## **CABINET MEMBER FOR ENVIRONMENT– 11 FEBRUARY 2016**

### **PROPOSED DISABLED PERSONS PARKING PLACES, VARIOUS LOCATIONS, OXFORD PLUS REMOVAL OF AN EXISTING PARKING BAY IN WINDMILL ROAD, HEADINGTON**

**Report by Deputy Director for Environment & Economy (Commercial)**

**Proposed DPPP  
Malford Road, Barton**

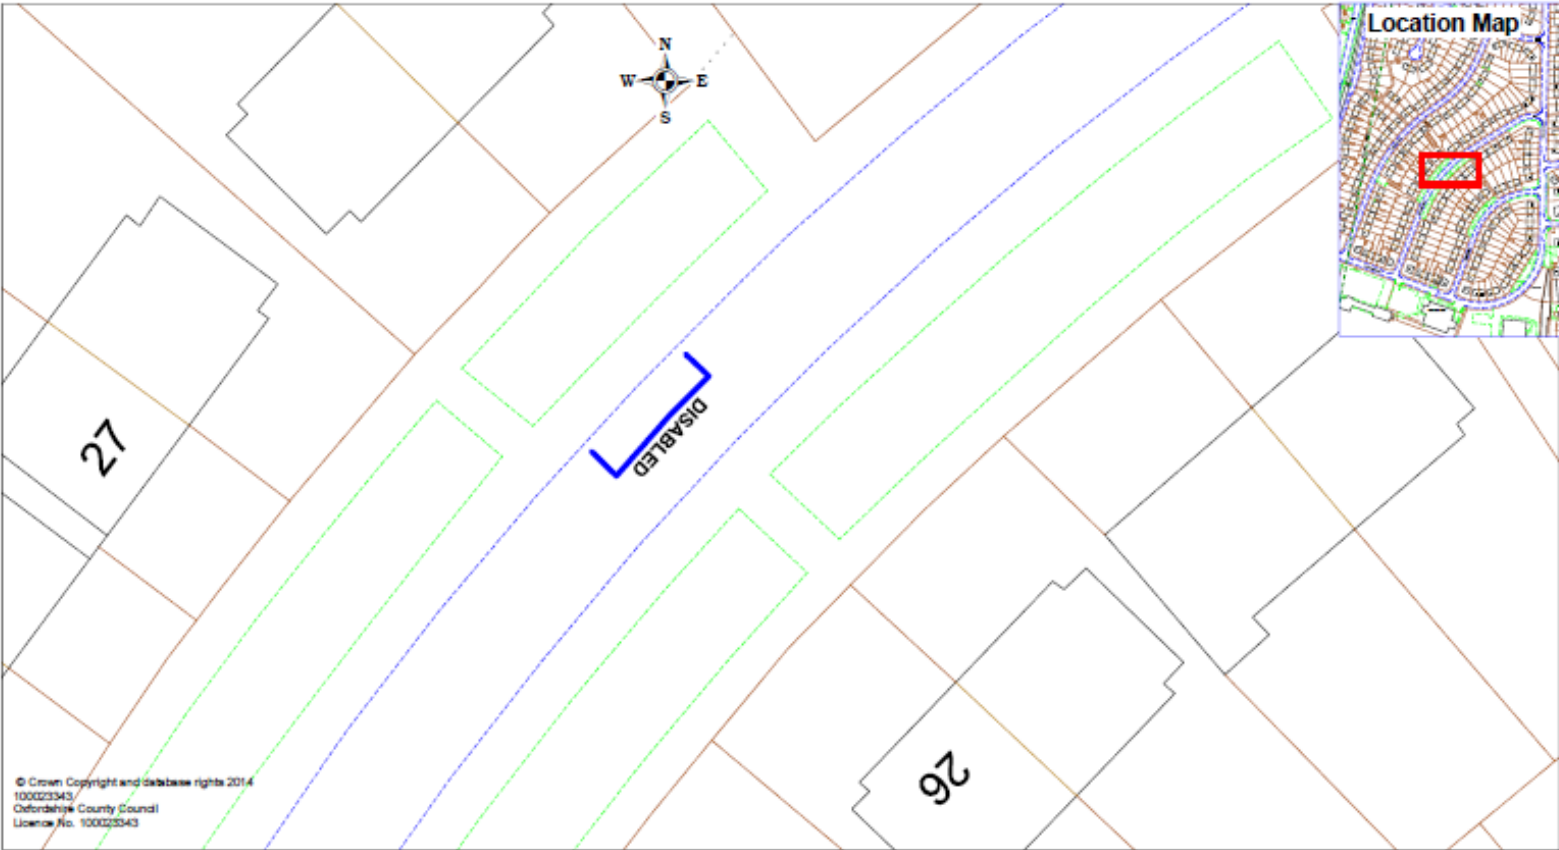
RESPONDENT	COMMENT	RESPONSE
<b>Proposed DPPP in Malford Road, Oxford</b>		
Resident, Malford Road	<p>The Street notice is inaccurate.</p> <p>Objects to the proposal as it would affect the value of their property. Their neighbour's home at No 33 is council owned and the bay would be better outside there because No 33 has off-road parking. This would be nearer for the applicant to walk.</p>	<p>The initial street notice was inaccurate but was changed promptly once this was realised; the letters sent to residents was accurate.</p> <p>As Malford Road is an adopted highway the frontagers have no individual rights over it and the matter of property value is not relevant. The applicant lives opposite No. 33 but has a grass verge in front of her property. She uses a tarmac footway to reach the road which is directly opposite the location of the proposed bay and the closest for her. The road is too narrow for parking on both sides and cars park between the dropped kerbs opposite the applicant's home. The objector has off-road parking.</p>

### Proposed DPPP, Quarry High Street

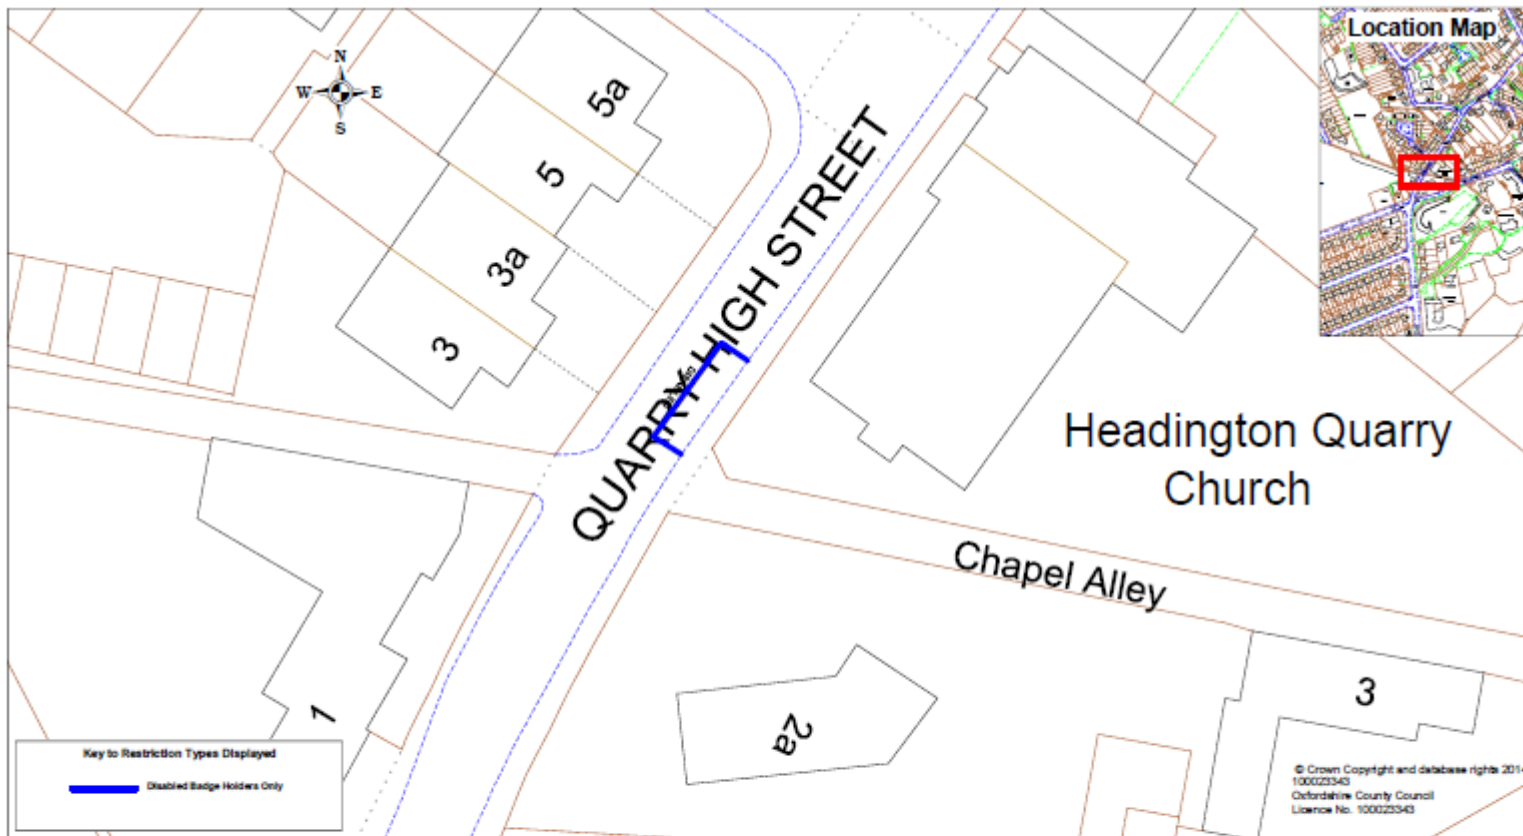
<b>Proposed DPPP in Quarry High Street, Oxford for Cornerstone Church</b>		
Resident, Quarry High Street	<p>Proposed bay would be opposite his home. The proposed location is not the problem, but believes a DPPP is not necessary. The church would only use the bay for 2 hours on Sundays when parking is available. They put out cones anyway which seems to be successful. During the week, parking is congested as commuters to the hospitals who cannot park in the nearby permit zones park here as well as residents.</p>	<p>The church advises they have services every Sunday and less frequent meetings at other times. The traffic cones (which have no legal status) are not always successful because other motorists move them to park themselves.</p>
